Re: Amendment to the Project Description, Vegetated Swale
San Francisco Electric Reliability Project (04-AFC-1)

Description of the Vegetated Swale

PB PB Power		A Professional Engineering Corporation	
1000 MARKET STREET, SUITE 100, SAN FRANCISCO, CALIFORNIA 94102			
SAN FRANCISCO ELECTRIC RELIABILITY PRODUCT		GRADING AND URNAGE PLAN	
MUNI SITE		C1.2	
DATE	PROJECT NO.	SCALE	SHEET NO.
10/20/11	10

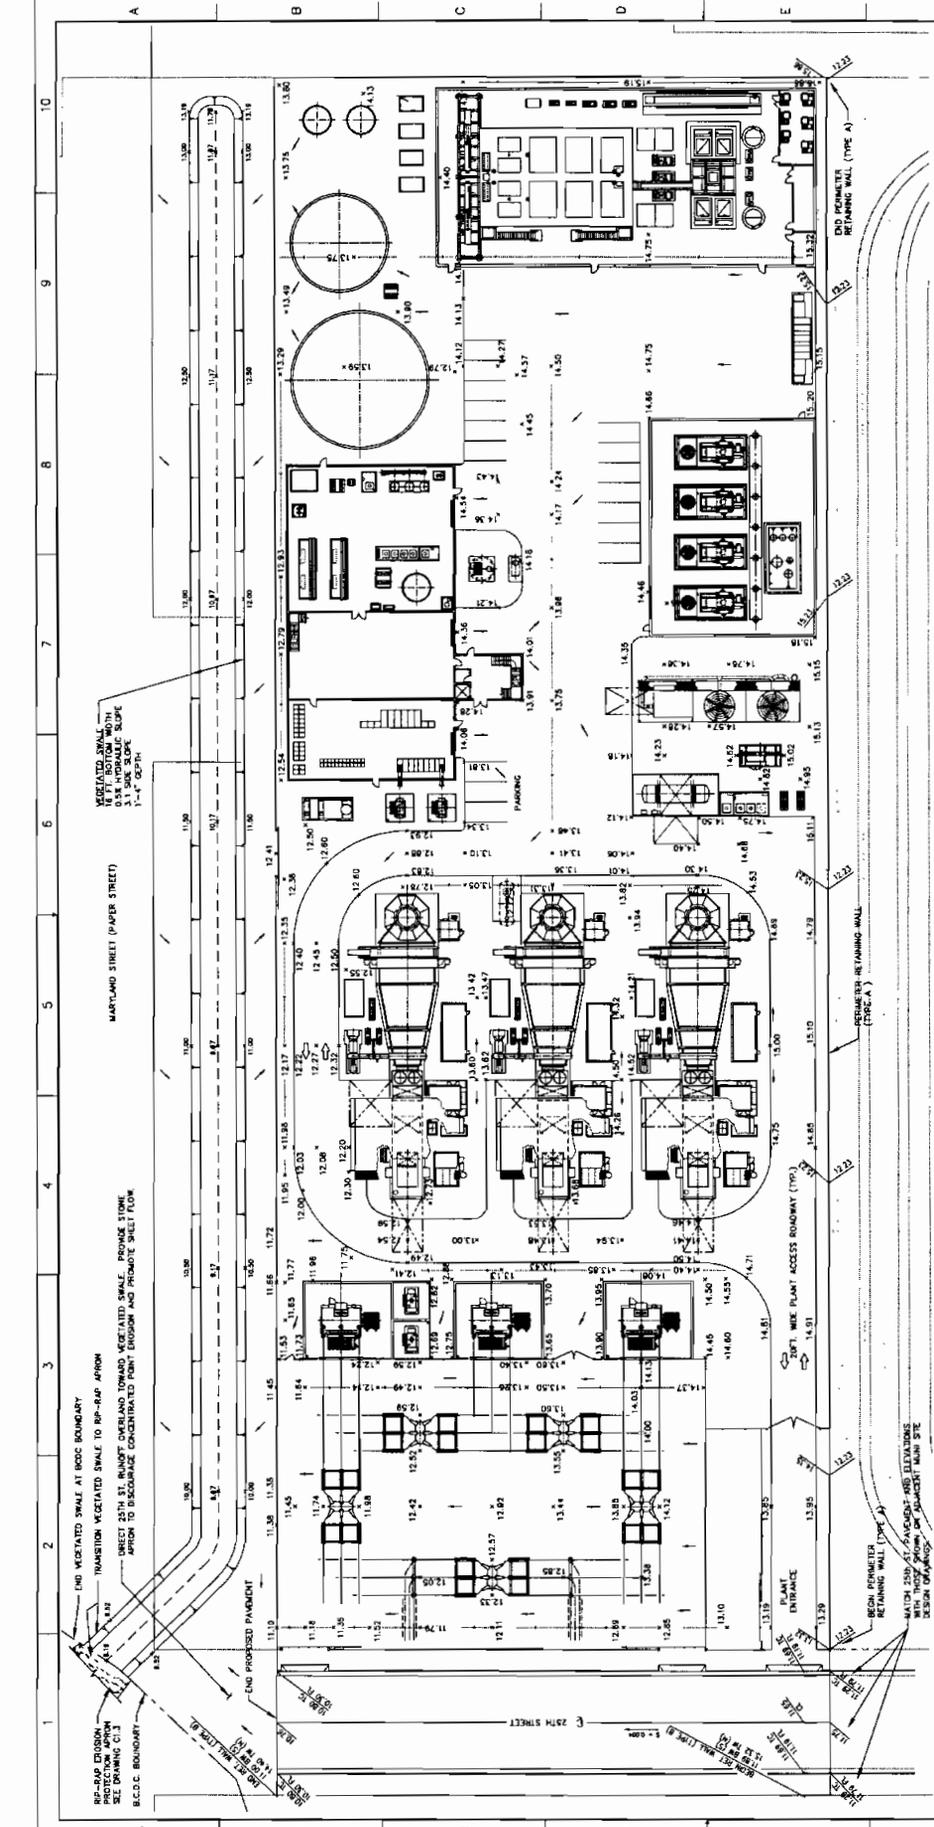
Post-construction treatment of stormwater will be accomplished by directing sheet flow from both the power plant site and 25th Street in front of the power plant into a Best Management Practices (BMP) stormwater treatment feature – a dry, vegetated swale. This method of stormwater collection and transport properly treats the stormwater prior to its discharge into the bay. Both the plant site and the street are impervious surfaces so the runoff coefficient for collection is conservatively assumed to be 0.99. The area between the plant site and the swale (as well as the area between the street and the swale) will be surfaced with vegetation similar to the grass in the swale. A membrane will be installed under the surface to ensure that no storm water percolates into the subsurface but rather is transported to the swale. From the swale, the water will then be transported to the Bay Conservation and Development Commission (BCDC) boundary where it will flow, after treatment, into the Bay via an outfall that spans the BCDC zone (see Figures C1.2 and C1.3).

To transport the stormwater across the BCDC property, a rip rap apron outfall was selected as a suitable transport means. In considering the design of the outfall it is noted that the swale itself is running at such a shallow pitch (0.5%), that the flow velocity anticipated in the swale (even for the 100-year storm event), is very low (0.39 ft/sec). Therefore, the riprap pad at the outlet point of the swale need not be significant. A riprap apron will be installed at approximately twice the width of the swale bottom width (say, 30 feet) with a median stone size of 3 inches. The apron should be composed of a well-graded mixture of stone sizes so that 50 percent of the pieces, by weight, are larger than the median size of 3 inches, but with a sufficient mixture of other stone sizes to fill the smaller voids between the stones. The riprap apron will be installed in a trapezoidal or fan shape, widening towards and meeting the more significant shoreline armoring, and then subsequently down the slope to the Bay.

- NOTES:**
- GRASS HEIGHT IN SWALE TO BE 8 INCHES. WATER QUALITY FLOW DEPTH TO BE 4 INCHES.
 - DECOMPOSED GRANITE TO BE 18 INCHES. WATER QUALITY FLOW DEPTH TO BE 4 INCHES.

- MINIMUM SLOPE TO BE 3 TO 1.
 - MINIMUM SWALE LENGTH TO BE 100 LINEAR FEET.
 - NO INFILTRATION INTO SUBSURFACE SOILS IS PRECLUDED. FLEXIBLE WATERPROOF GEOMEMBRANE TO BE INSTALLED 3 TO 3 1/2 FEET BELOW THE VEGETATED SWALE.
